30 Monument Street Single Family Residence  
Project Summary

## Jeanie Bourke - Re: 30 Monument St. Bp#2014-02773

Address/Location of Construction: 30 Monument Street		
Total Square Footage of Proposed Structure:		same
Tax Assessor's Chart, Block & Lot Chart#      Block#      Lot# 16-E-10	Applicant Name: Brewster Buttfield Address 58 Fore Street City, State & Zip: Portland, ME 04101	Telephone: 207-749-7400 Email: brewster@prospectdesign
Lessee/Owner Name: Rich Robinov (if different than applicant) Address:  City, State & Zip: Portland, ME Telephone 207-747-9084 E-mail:	Contractor Name: Cornerstone Build (if different from Applicant) Address: 100 Congress St. City, State & Zip: Portland, ME 04101 Telephone 207-939-0185 E-mail:	Cost Of Work: \$ C of O Fee: \$ Historic Rev \$ Total Fees : \$ 69.00
Current use (i.e. single family) <small>single family</small> If vacant, what was the previous use? Proposed Specific use: <small>single family</small> Is property part of a subdivision? ___ If yes, please name _____ Project description: This is an addendum to permit number BP# 2014-02773. Addition of finished basement, emergency egress well and details on one hour wall.

SHEET TITLE  
EXISTING ELEVATIONS  
CONSTRUCTION SET

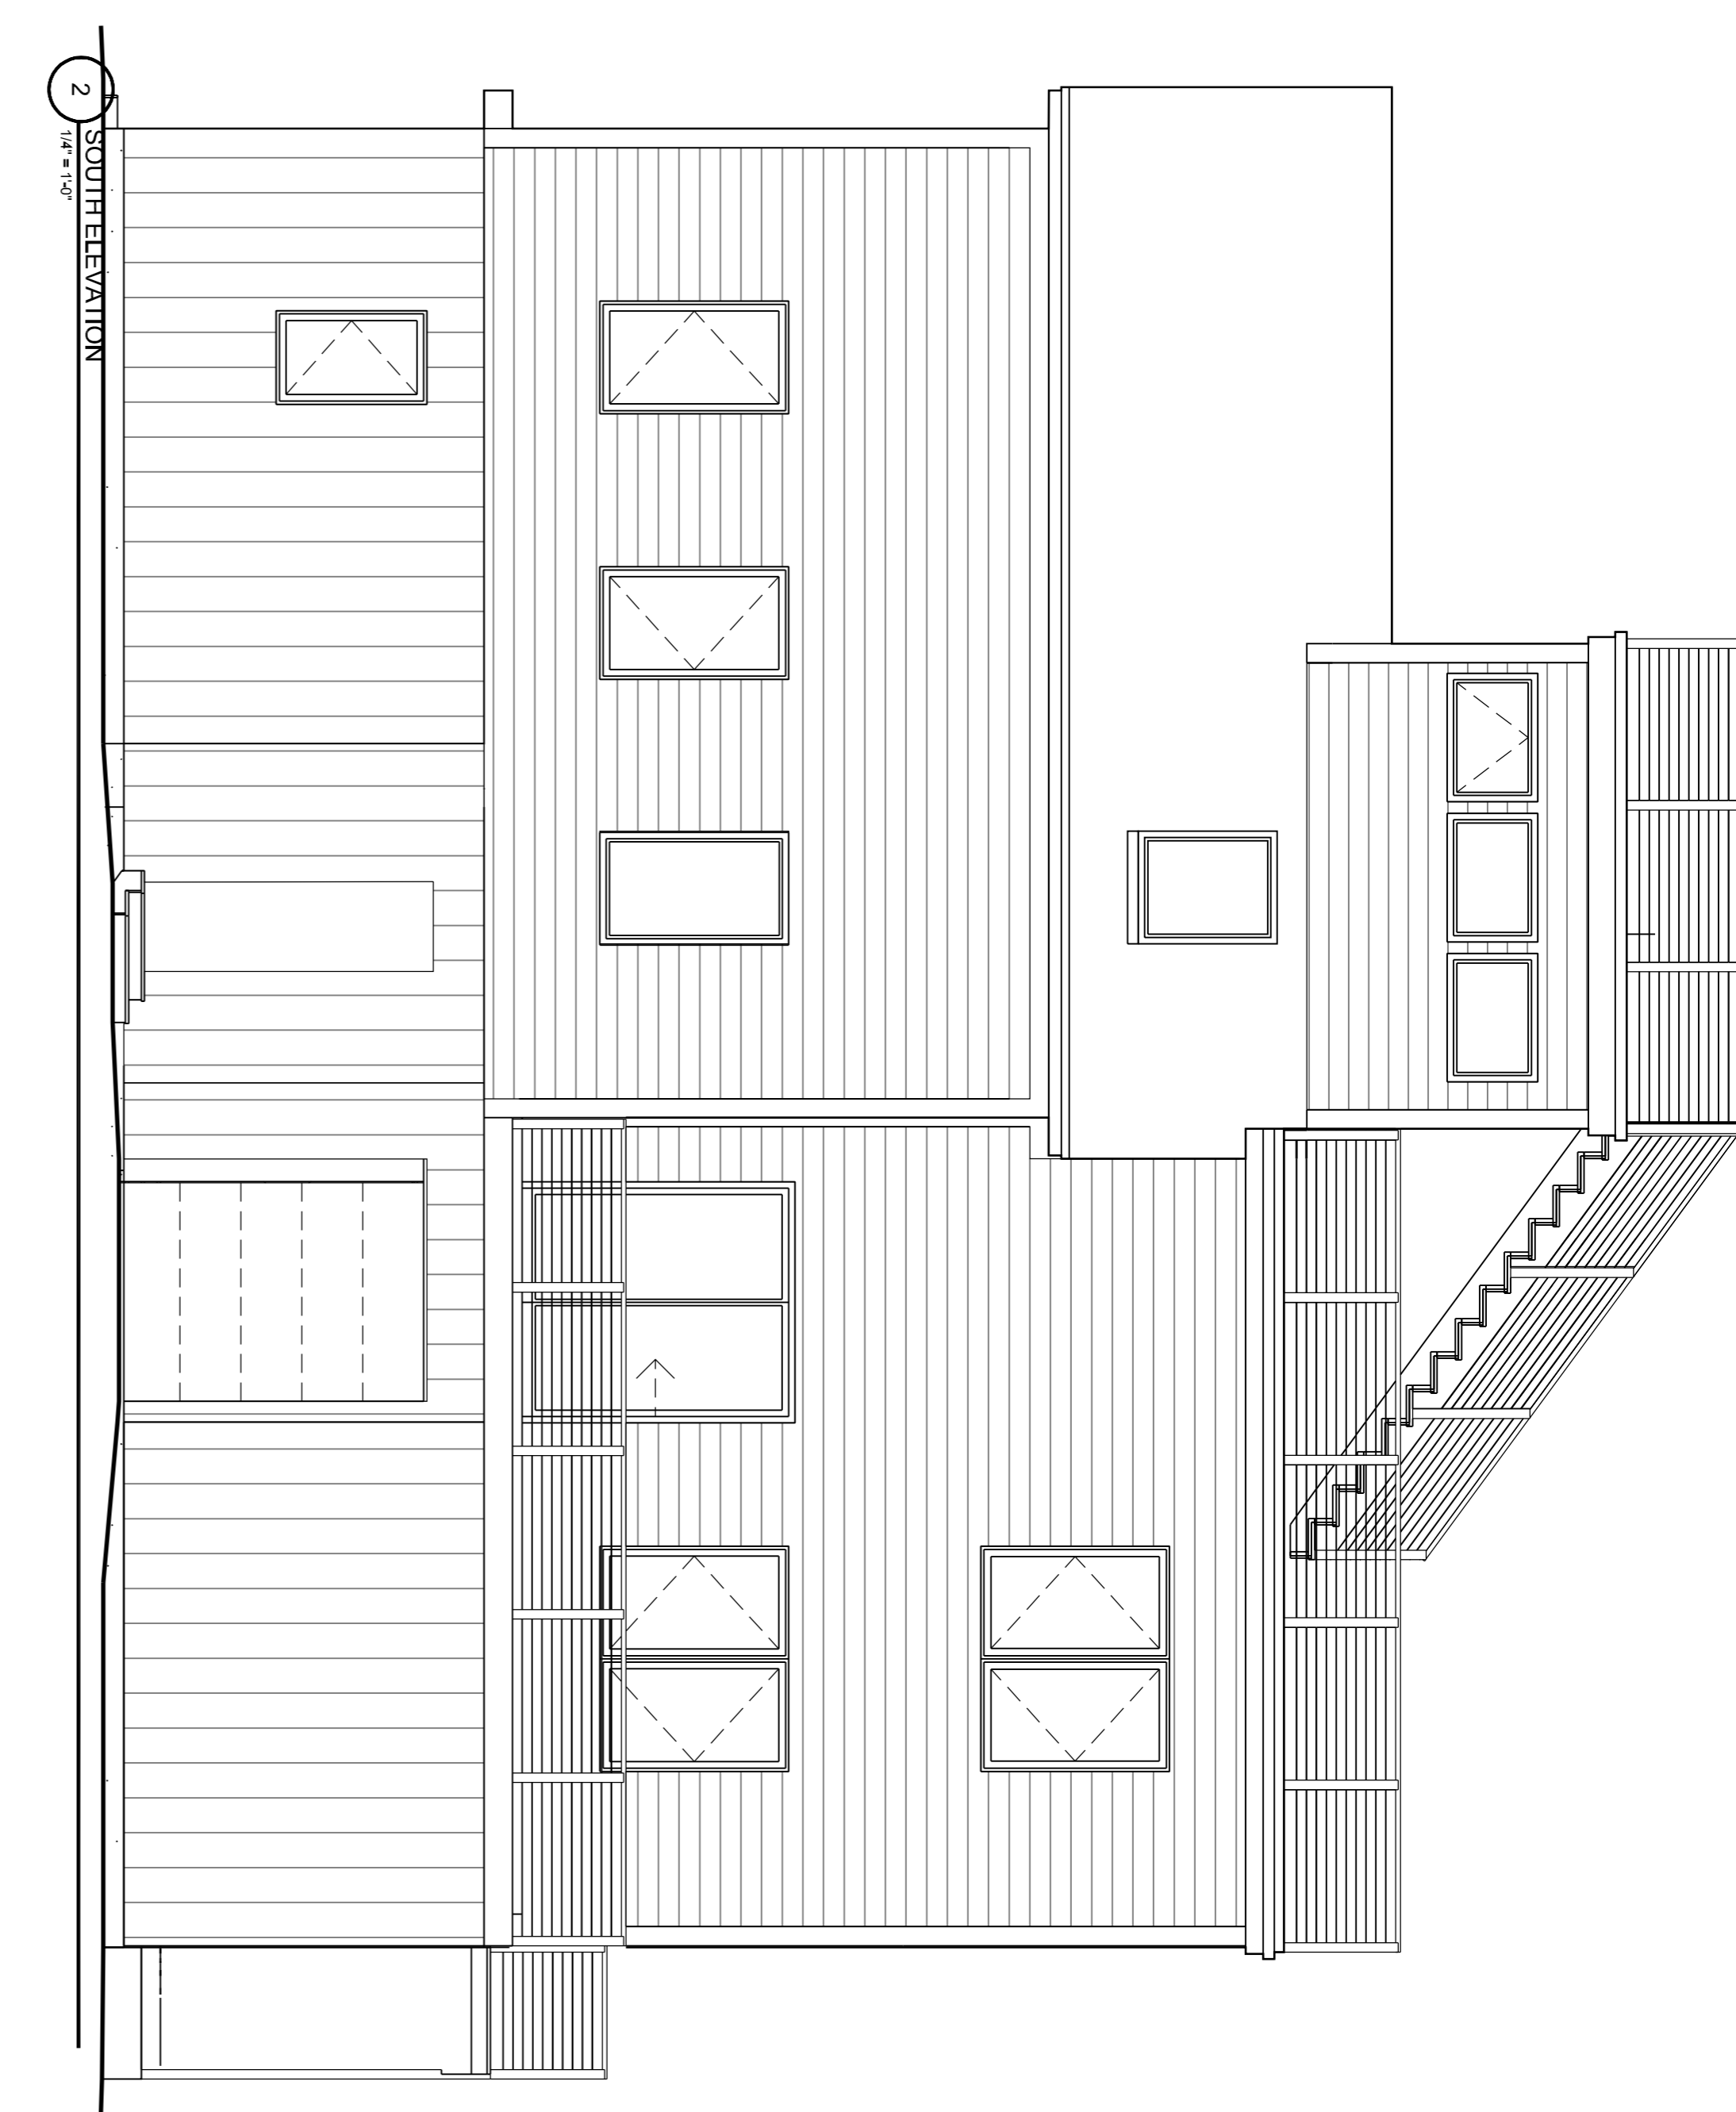
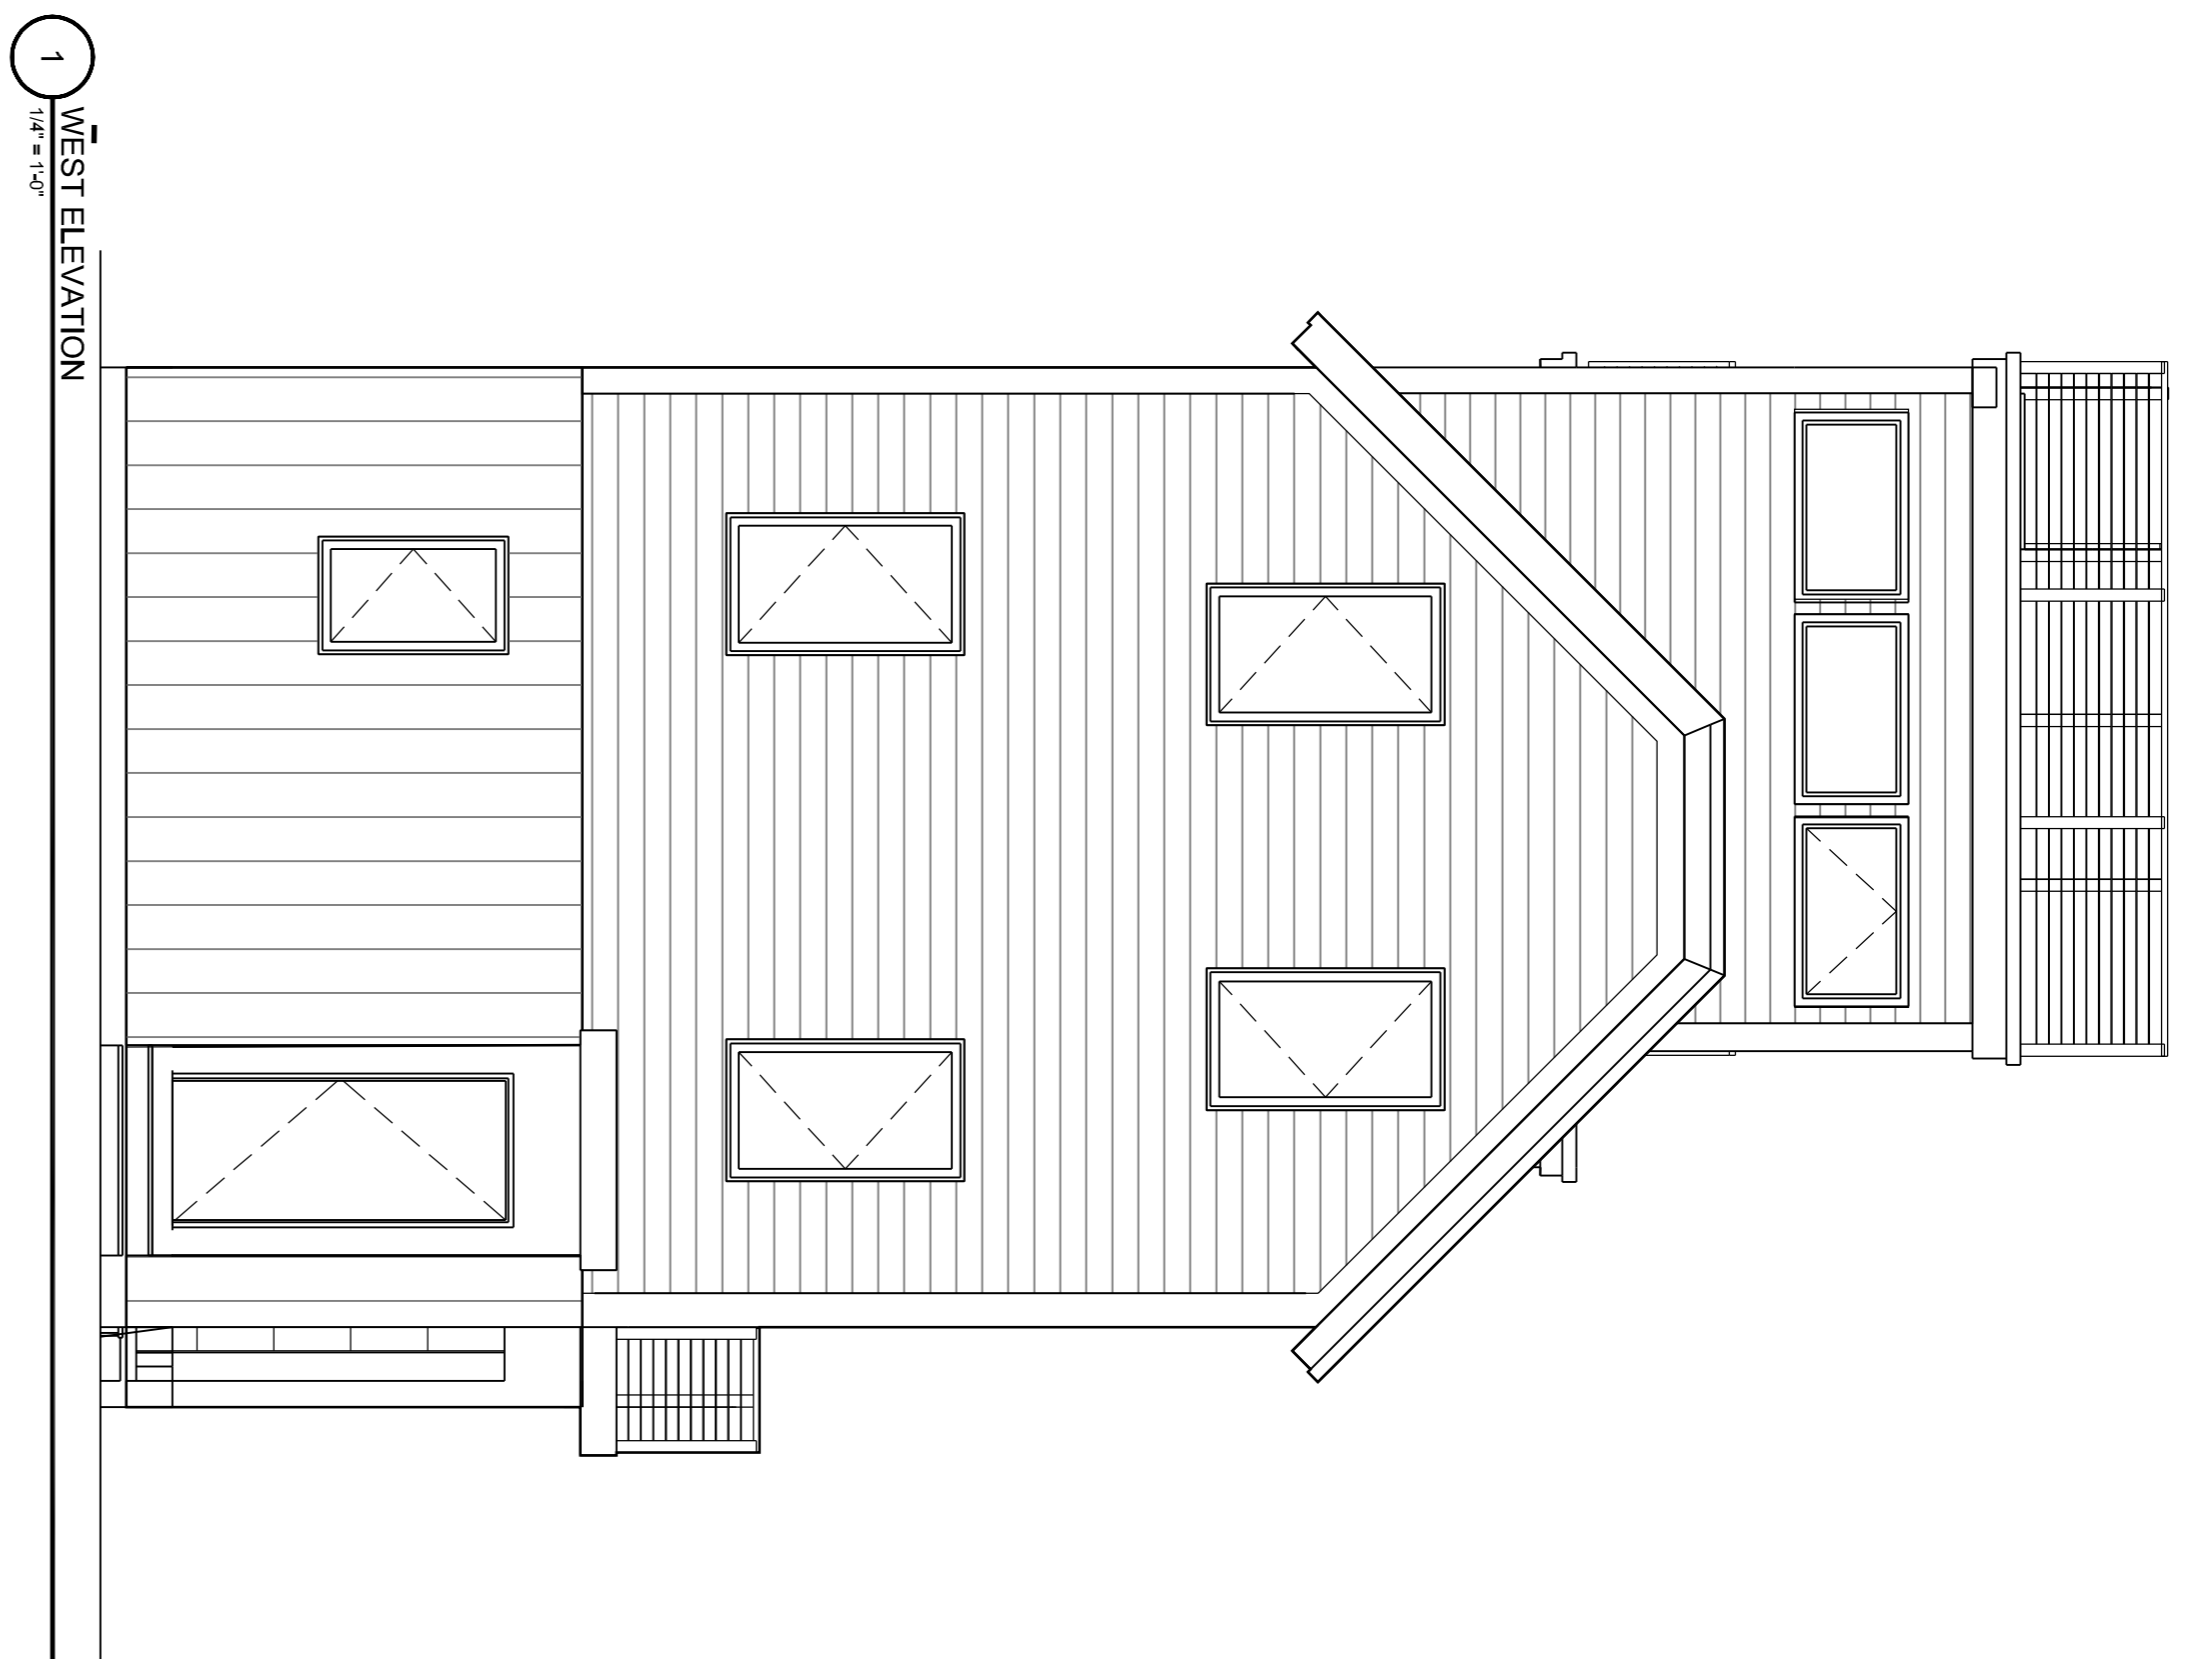
2. The window quantity is actually the same if you can the original basement windows (see photo below). The actual area of glass is reduced in the proposed plan by 17 sq.ft. This is shown on the existing and proposed elevation drawings. **This is acceptable.**

1. Provide a 1 hour exterior wall detail, rated from both sides per Table 302.1 and UL 263 for the northeast wall.
2. Provide the percentage of glazing & openings of the existing and proposed northeast wall. With this

February 4, 2015  
March 5, 2015 SHOW GLASS AREA ON THIS FACE  
BB  
March 5, 2015
